RAINMAKER TECHNOLOGY CORPORATION

Response to FAA Request for Information

AFS-26-02197-E

Docket No. FAA-2025-1630 | Exemption No. 25287

Figure 1: Graphical representation of the 4 flare configuration

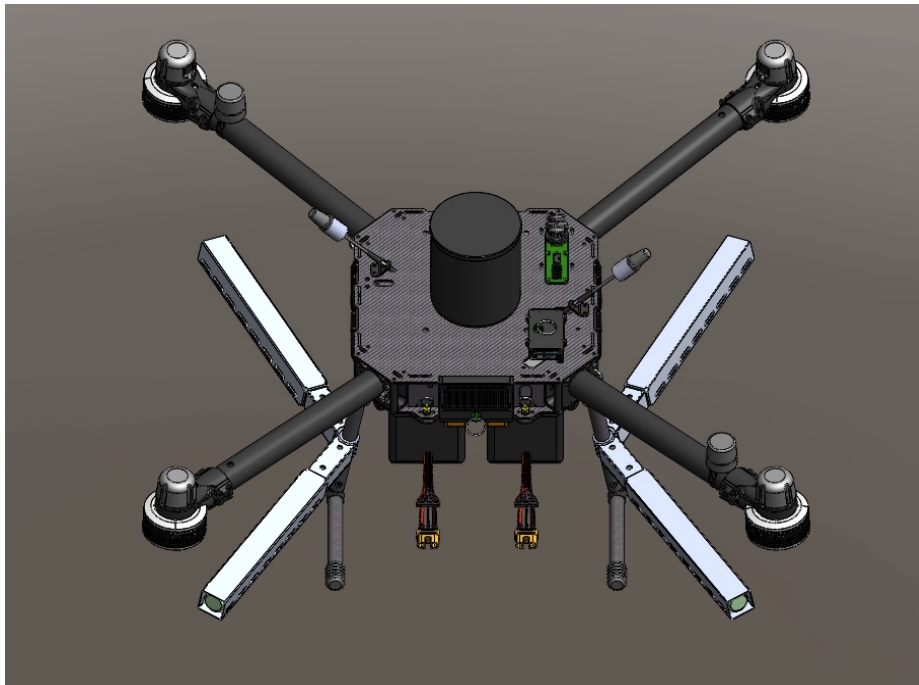
Description: Phase 1 authorizes operations with a maximum of four (4) flares per aircraft. This phase serves as an operational validation period to confirm system integration, structural integrity, and safety performance of the increased flare payload before progressing to the full six-flare configuration.

Aircraft and Flare Configuration: Rainmaker Elijah Quadcopter Series with up to four (4) Zeus (BIP) or Ikarus (Ejectable) flares, mounted symmetrically on landing legs using the aluminum Flare Holder Assembly with vibration-resistant clevis pins and shaft collar retention. Total takeoff weight not to exceed 55 lbs.

Duration: Phase 1 continues until a minimum of 50 successful operational flights with 4 flares have been completed with zero safety anomalies due to malfunctions of the flares or holder assembly.

Figure 2: Graphical representation of the 6 flare configuration

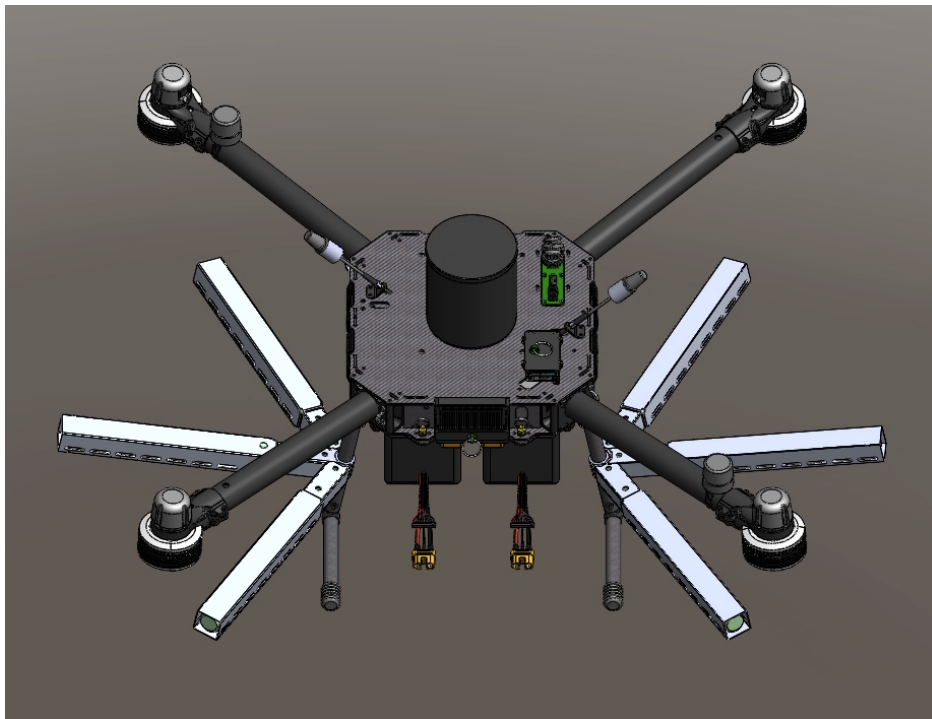
Description: Phase 2 authorizes operations with a maximum of six (6) flares per aircraft, representing the full amended capability.

Aircraft and Flare Configuration: Rainmaker Elijah Quadcopter Series with up to six (6) Zeus (BIP) or Ikarus (Ejectable) flares, mounted symmetrically on landing legs. Total takeoff weight not to exceed 55 lbs.
